DECISION OF THE SALEM PLANNING COMMISSISON

CLASS 3 DESIGN REVIEW / CONDITIONAL USE PERMIT / CLASS 3 SITE PLAN REVIEW / CLASS 2 ADJUSTMENT CASE NO.: DR-CU-SPR-ADJ21-02

SUMMARY: A consolidated application for a proposed new building and vehicle use area serving 34-unit multiple family development.

YMCA Apartments
220 Cottage Street NE
Salem, Oregon
11/20/2020
Revised 2/4/2021
Revised 3/4/2021

1 ARCHITECTURAL SITE PLAN
 A100 1" = 10'-0"

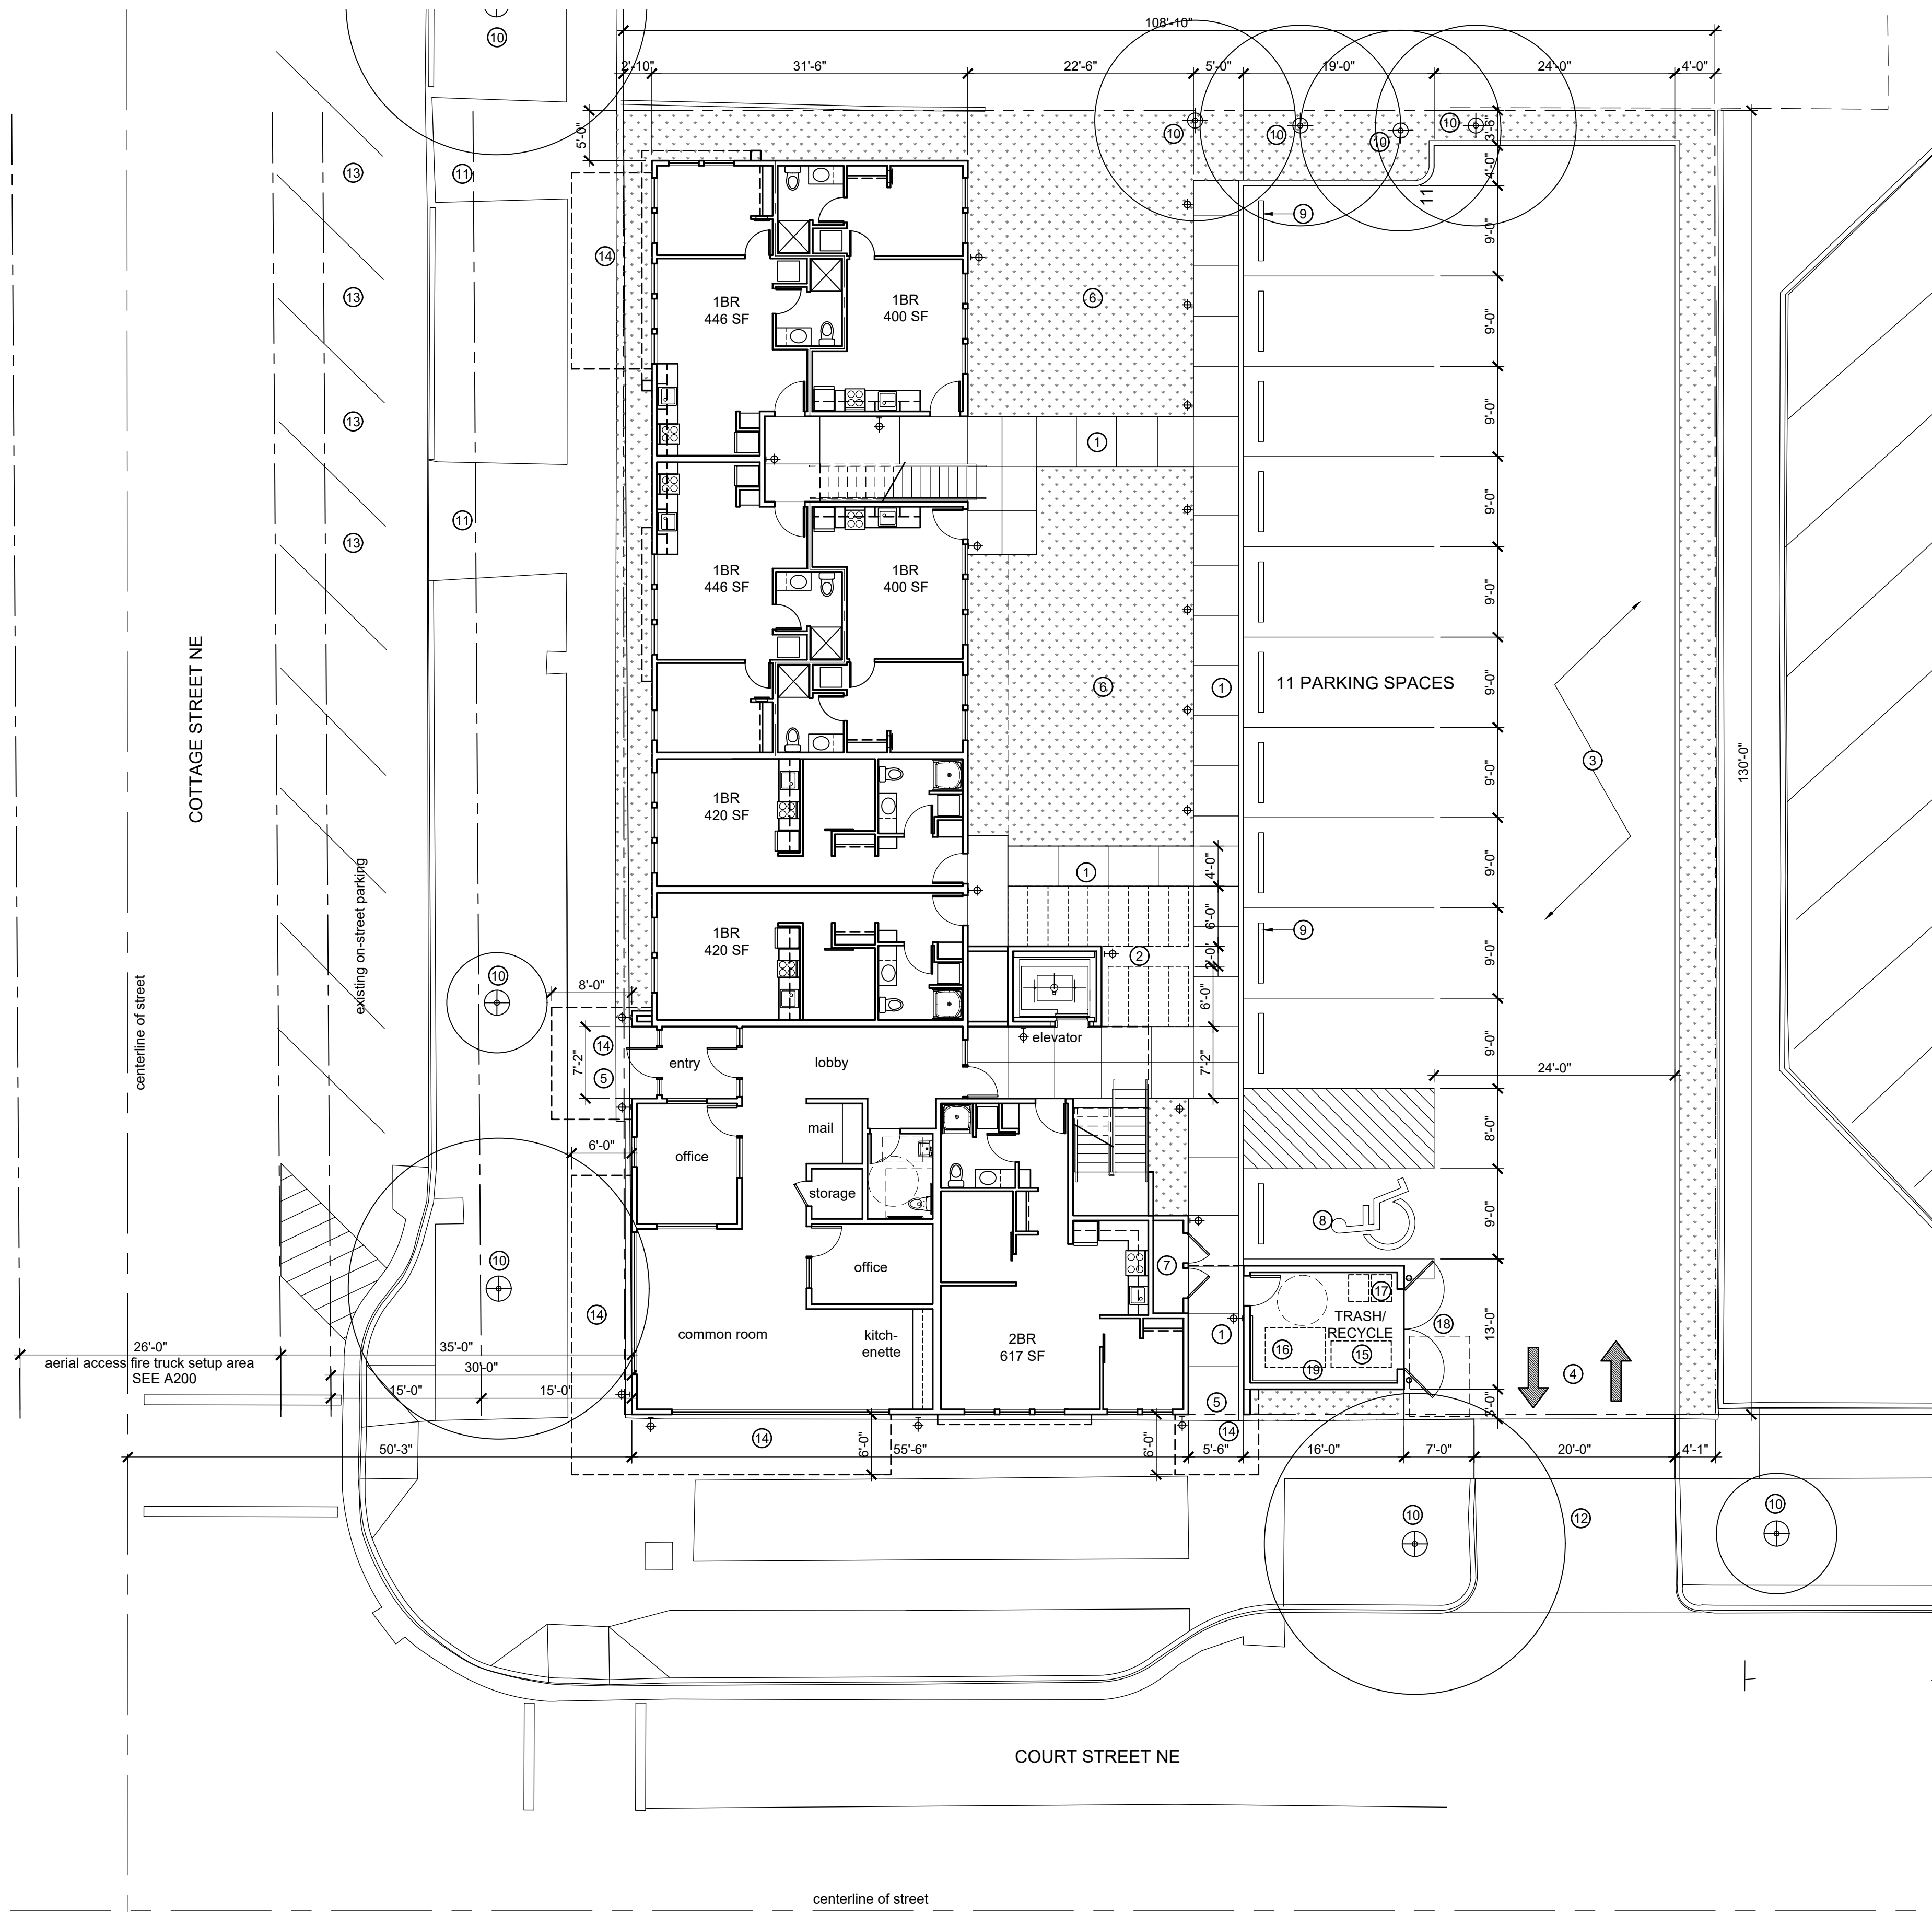
As illustrated on the site plan, the proposed building satisfies the minimum setback requirements of SRC Chapter 522 and SRC Chapter 806 with the exception of the following:

- **Building Setback Abutting Street.** As summarized in the table above, the CR zone requires buildings to be setback five foot from the property line abutting the street. As shown on the site plan, the proposed building has a varying setback adjacent to the street. In some locations the building is constructed contiguous to the property line abutting the street and in other locations the building is setback between 0 ft. and two feet ten inches. Since the entire building is not proposed to be set back five feet from the street right-of-way, the building does not meet the building setback from the street required by in the CR zone; instead, the building has been designed to conform to the General Retail/Office Overlay Zone design guidelines that call for building setbacks from the street to be minimized. Because the CR zone street setback requirement is not met, a Class 2 Adjustment to this standard has been requested in conjunction with the proposal.

As shown on the site plan, the vehicle use area is proposed to be approximately three-feet abutting Court Street NE, approximately four feet from the east property line, where ten-feet is required and approximately three feet from the north property line, where ten feet is required. Because the proposed surface parking lot/vehicle use does not meet the minimum required setback, a Class 2 Adjustment to this standard has been requested as part of the application.

As shown on the site plan for the proposal, eleven standard size stalls are provided. The standard size stalls conform to the minimum required 9-foot width and 19-foot depth. The parking stalls within the development are served by 24-foot-wide in conformance with the requirements of SRC 806.035(e), Table 806-6.

Finding: As previously indicated on the site plan the bicycle parking spaces provided are in proximity to and easily accessible from the buildings ADA entrance, which is greater than 50-feet from the primary entrance not in conformance with the requirements of SRC 806.060(a). The applicant has requested a Class 2 Adjustment, which is addressed below. The site plan indicates a bicycle rack with four spaces has a four-foot access aisle and the rack appears to meet the current standards in Figure 806-10. The rack is near a ramp preventing the need to lift the bike over a curb. The proposed bike racks are greater than 50-feet from the primary building entrance; an adjustment has been requested and is addressed below.

As shown on the site plan for the proposed development, the solid waste service area is covered, enclosed by an six-foot-tall perimeter wall, has an interior dimension within the enclosure of approximately 12ft in. in width by 8 ft.-6 in. in depth, has a front opening of 8 feet, and is has an eight foot clearance of vertical obstructions above the receptacles. The applicant is requesting an adjustment from 12-foot opening to 8-foot opening, which is addressed below. The site plan indicates that the base of the enclosure will be a concrete slab, consistent with these design standards. Adequate separation distance is provided within the enclosure. Receptacles will not be placed within 1.5 feet of the enclosure walls and at least five feet from any other building or structure. An enclosure is provided for the solid waste service area that is proposed to be constructed of opaque materials which will screen the solid waste service area from abutting properties and streets.

Condition 2: Prior to issuance of building permits, a property line adjustment shall be finalized to consolidate the underlining properties, or an adjustment shall be approved to eliminate the setback standards.

Condition 4: The applicant shall close the existing driveway approaches along Cottage Street NE, reconstruct curb and re-stripe on-street parking pursuant to PWDS.

Condition 5: The applicant shall design doorways abutting Cottage Street and Court Street to not encroach into the right-of-way.
